Technical Bulletin

Bulletin No: TCH-001-000

Subject: "CLEAN ENGINE" TU-FLO 501 COMPRESSOR

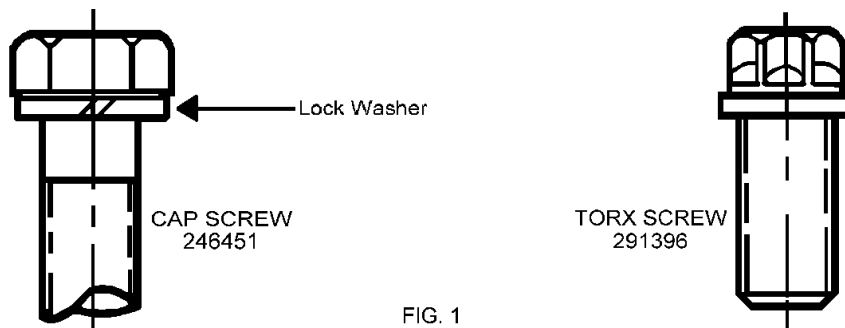
1. The hex head cap screws and lock washers used to fasten the flange adapter on Detroit Diesel compressors will be replaced by torque screws with Dri-loc on the threads. This will eliminate a possible seepage through the lock washer gap which ultimately appears as a leak between the flange adapter and the crankcase. The torque screws have been used on Cummins compressors for some time. The difference in the bolt heads is shown in Figure 1.

2. On all flange type compressors using the sheet steel crankcase plate, a new thicker gasket 293349 will provide a more positive oil seal.
3. The oil return holes have been sealed between crankcase and flange adapter by an o-ring 292437 in a counter bore in the crankcase. See Figure 2. This construction has been revised to achieve more positive sealing, using a larger section o-ring 293347 and a support bushing 293348. See Figure 3.
